MFN 10-089 Revision 2

Docket No. 52-010

Subject: **Revised Response #2 to NRC RAI Letter No. 409 Related to ESBWR Design Certification Application – DCD Tier 2 Section 10.2 – Steam and Power Conversion System; RAI Number 10.2-18 S03**

Figure 10.2-2. Turbine Control Valve Fast Closure Characteristic

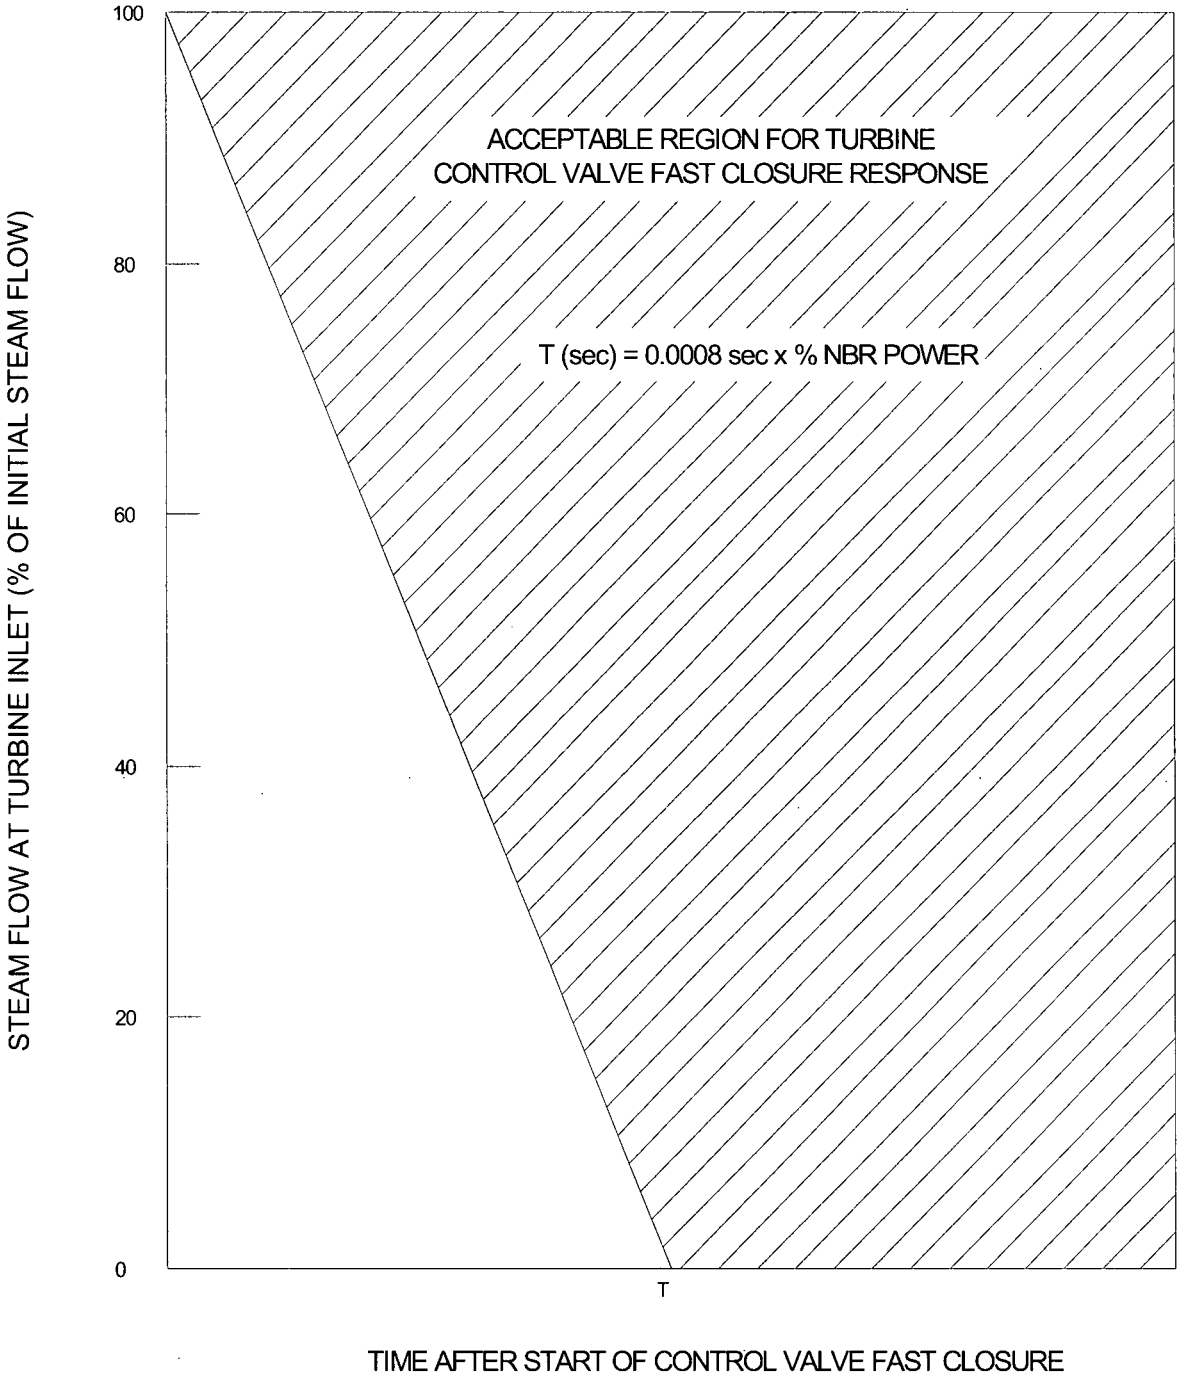
Section 10.2.1.3.2: First sentence, include the reason for the times shown in Figure 10.2-2 (e.g., to comply with transient requirements).

During any event resulting in turbine control valve fast closure, the turbine inlet steam flow is not reduced faster than that shown in Figure 10.2-2 to comply with the transient requirements.

Figure 10.2-3. Acceptable Range for Control Valve Normal Closure Motion

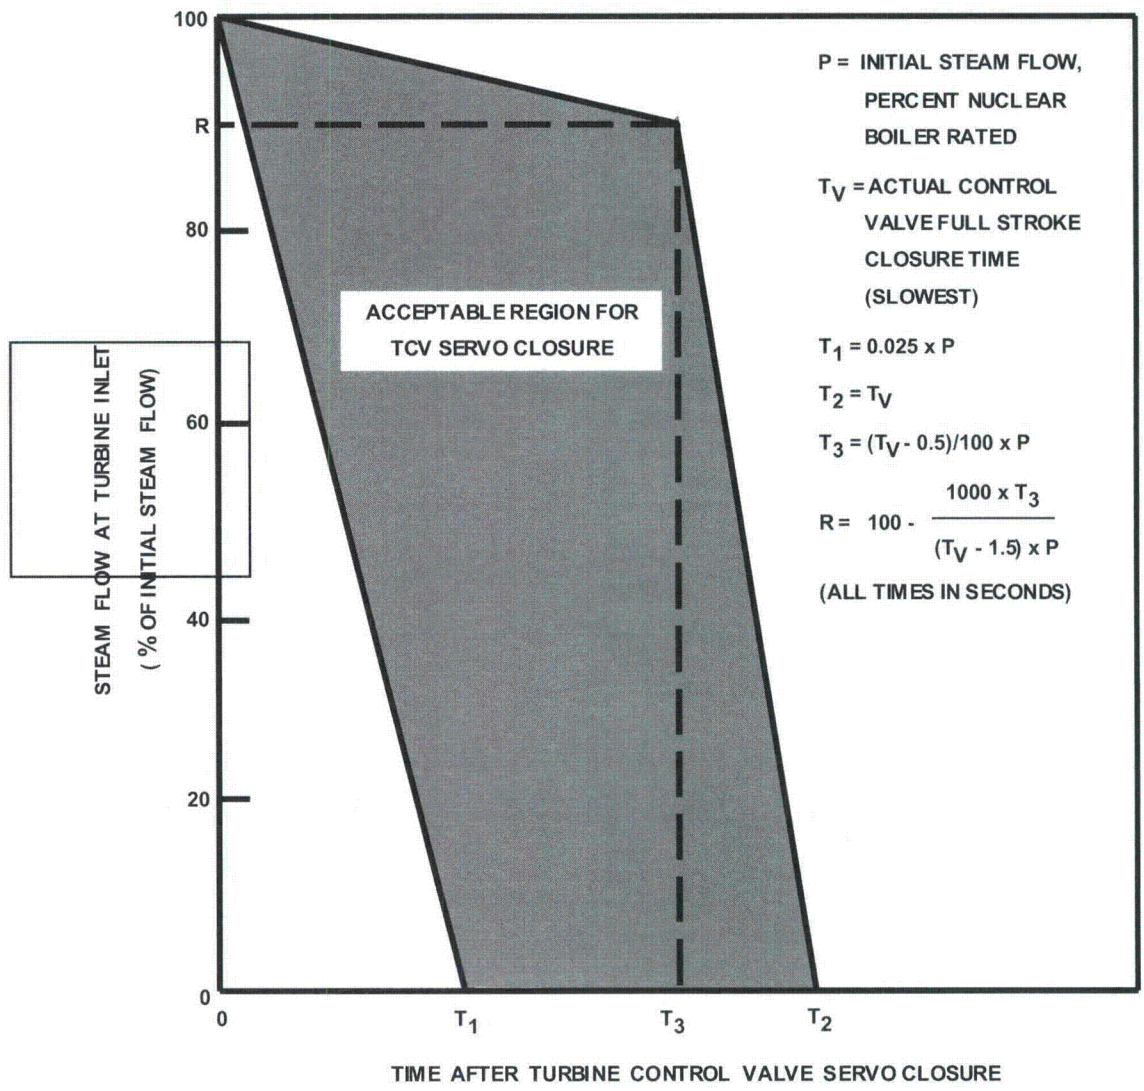
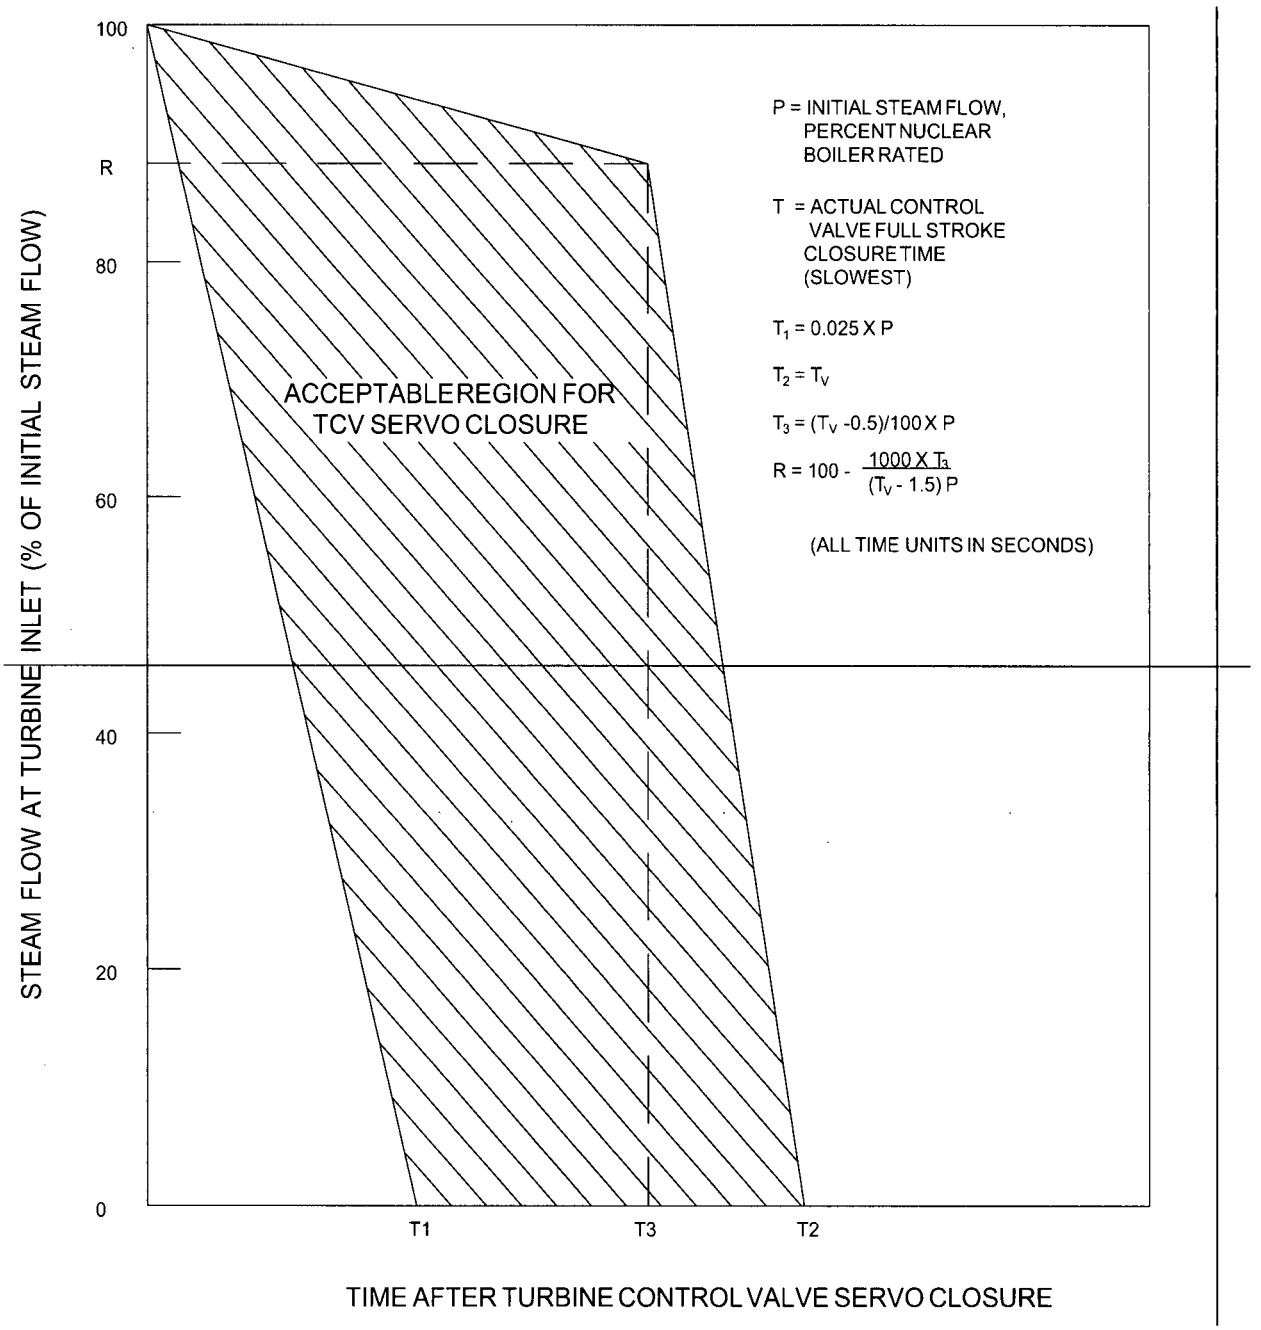
6) *The bases for the times shown in Figures 10.2-1, 10.2-2, and 10.2-3 are not explained* ***[the distinction between Figures 10.2-2 and 10.2-3 has not been adequately addressed in the proposed DCD markup];*** *and T_v is not defined on Figure 10.2-3.*

DCD Figure 10.2-3 has been corrected by adding the missing subscript "v" from T_v.

Enclosure 2 includes the revised DCD Figure 10.2-3. DCD Subsection 10.2.1.3 has been revised to indicate that DCD chapter 15 has the required information for the valve response figures.

Figure 10.4-6a. Low Pressure Extraction Steam System

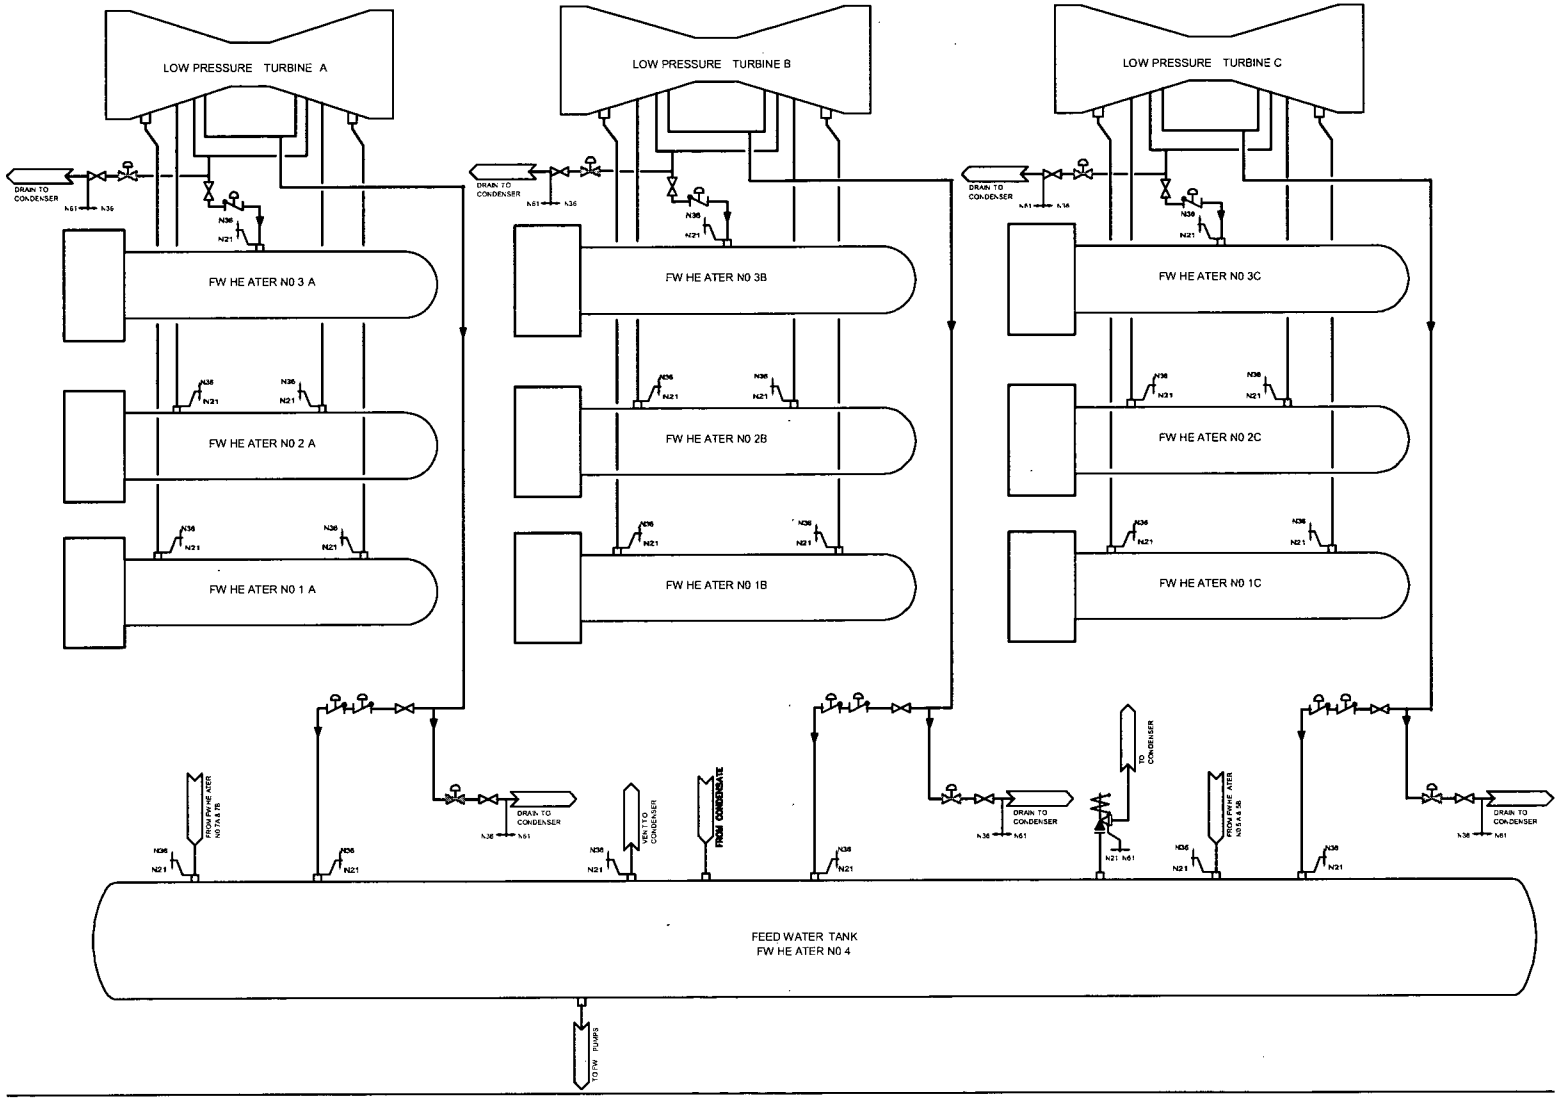
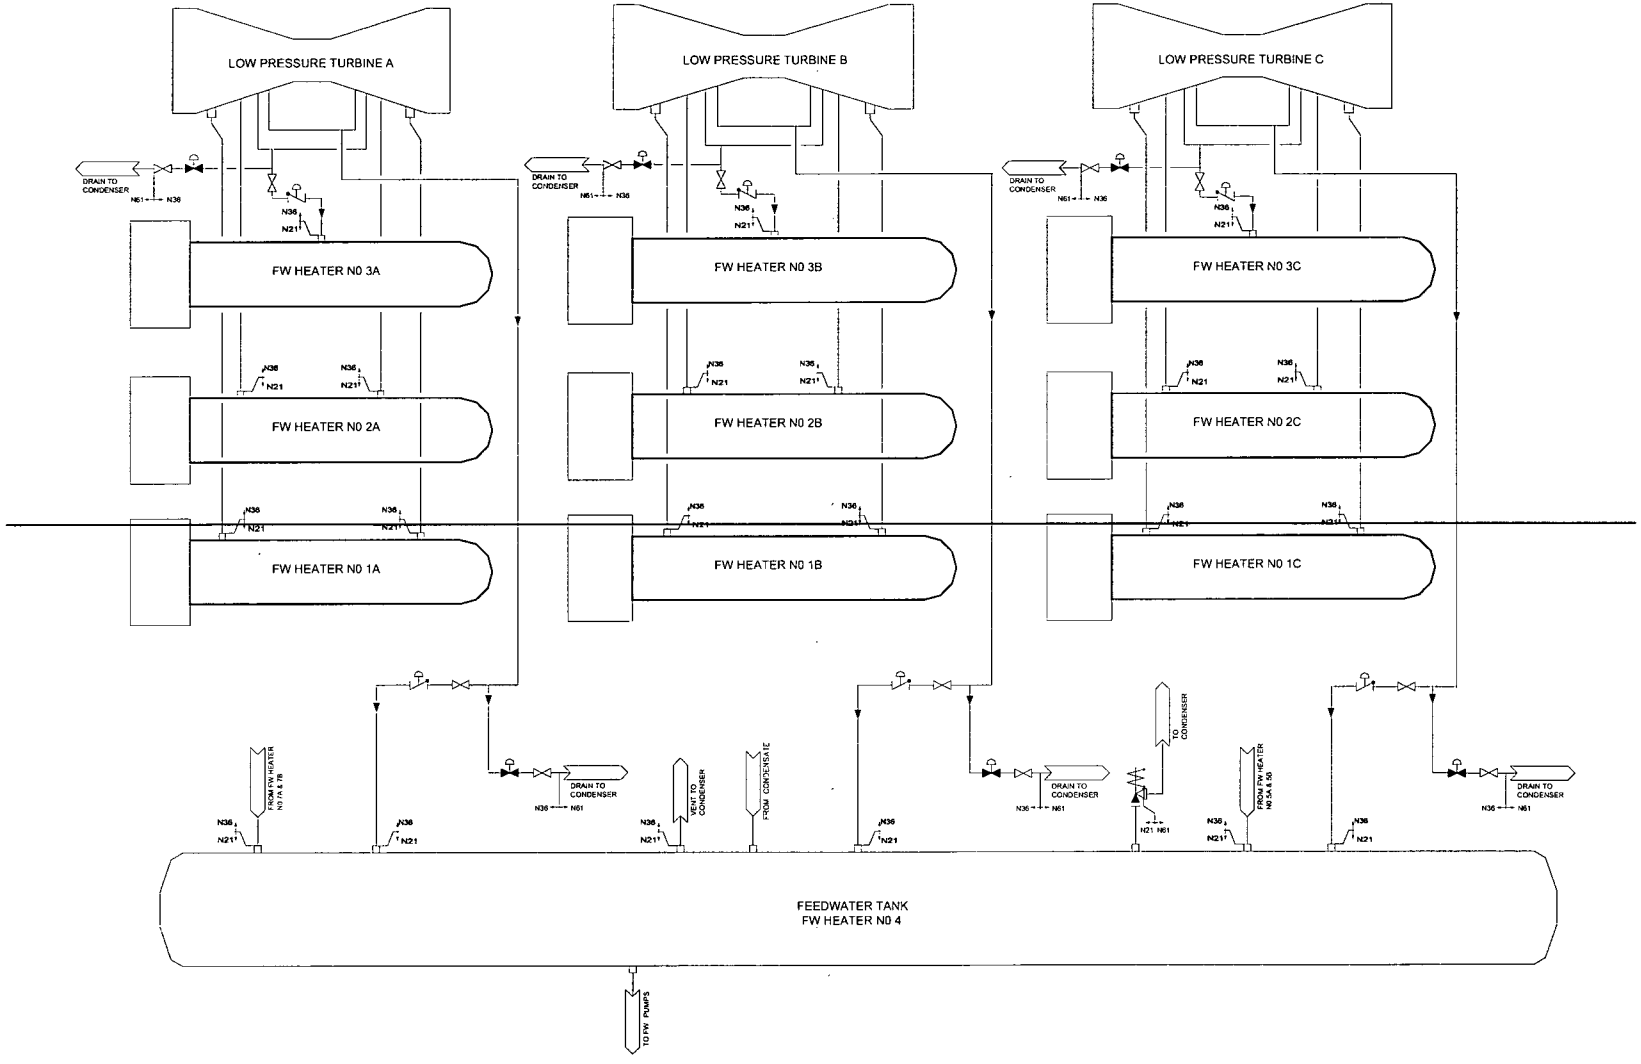
GEH has provided inconsistent information concerning where non-return valves are located and to what extent they are needed in order to prevent the turbine from exceeding 120% rated speed, including consideration of single failures. [NRC] current understanding based on the most recent information that was provided is that both power assisted and simple non-return check valves need to be credited to prevent the turbine from exceeding 120% rated speed during a loss of load event. The proposed revision in the February 28 e-mail response provides an acceptable description. However, the Tier 1 functional diagram needs to be revised to include simple non-return check valves that are needed to prevent the turbine from exceeding 120% rated speed.

DCD Figure 10.4-6a has been revised to correct the quantity of non-return valves required for the number four (4) open feedwater heater. This is also discussed in DCD Subsection 10.2.2.2.6.

The proposed DCD Subsection 10.2.2.2.6 and Figure 10.4-6a shows the location and quantity of spring assisted extraction steam non-return valves that are required on the
